# Staff Report to the Ogden Valley Planning Commission

**Application Request:** Consideration and action for a request to amend a previously approved conditional use for the Trapper's Ridge at Wolf Creek P.R.U.D. The amendment will add Phase 8, consisting of 18 lots, to the existing multi-phased P.R.U.D. This P.R.U.D. amendment will run concurrently with the request for preliminary subdivision approval of the Trapper's Ridge at Wolf Creek P.R.U.D. Phase 8, located within the approved Wolf Creek Resort Master Development.

**File Number:** CUP2016-07

TRAPPERS RIDGE AT WOLF CREEK P.R.U.D. PHASE 8

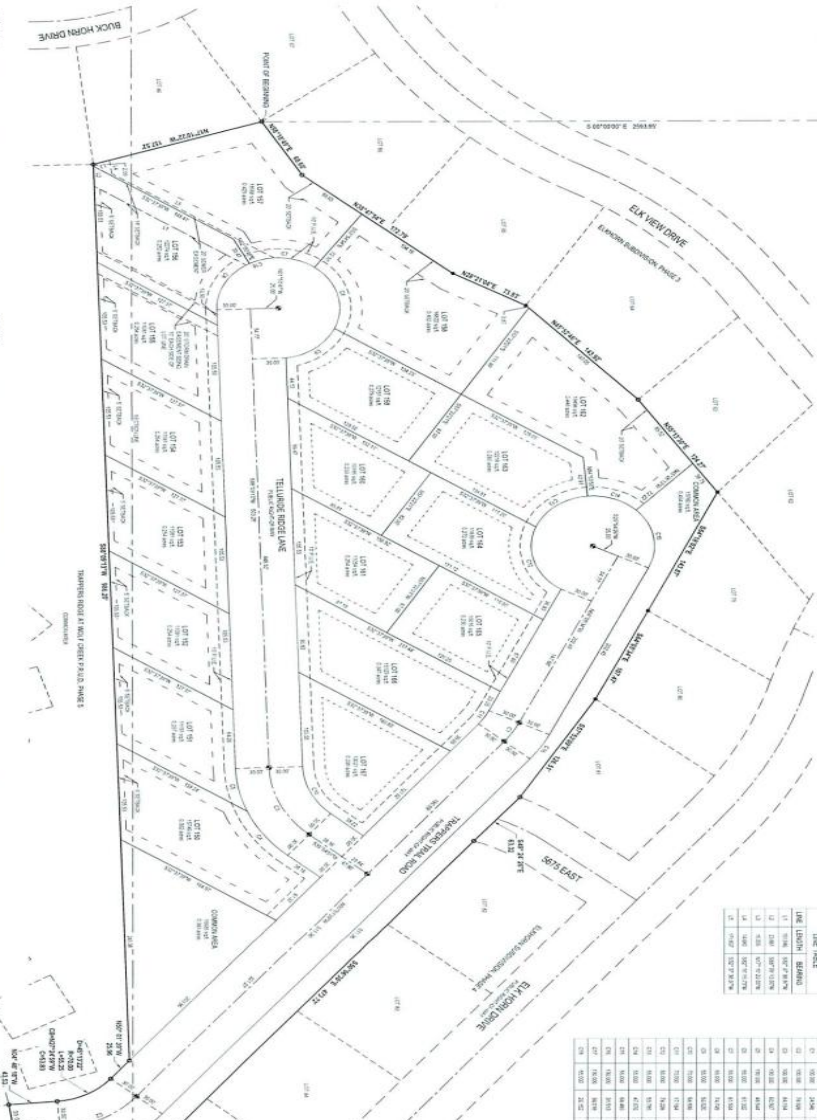
Based on the allowed flexibility of a PRUD, the proposed layout, lot configuration and lot size are acceptable. Staff recommends a "No Access" note and line to be added to the proposed Lot 166 along either Trappers Trail Road or

Telluride Ridge Lane to restrict access per LUC §106-2-4(c) which prohibits interior lots from having frontage on two streets except where unusual conditions make other design undesirable. A condition of approval has been added to staff's recommendations to ensure the final subdivision is submitted with the required "No Access" note on the plat.

1. A "No Access" note and line will be placed on lot 166 on the final plat limiting access to lot 166 from either Trapper's Trail Road or Telluride Ridge Lane.
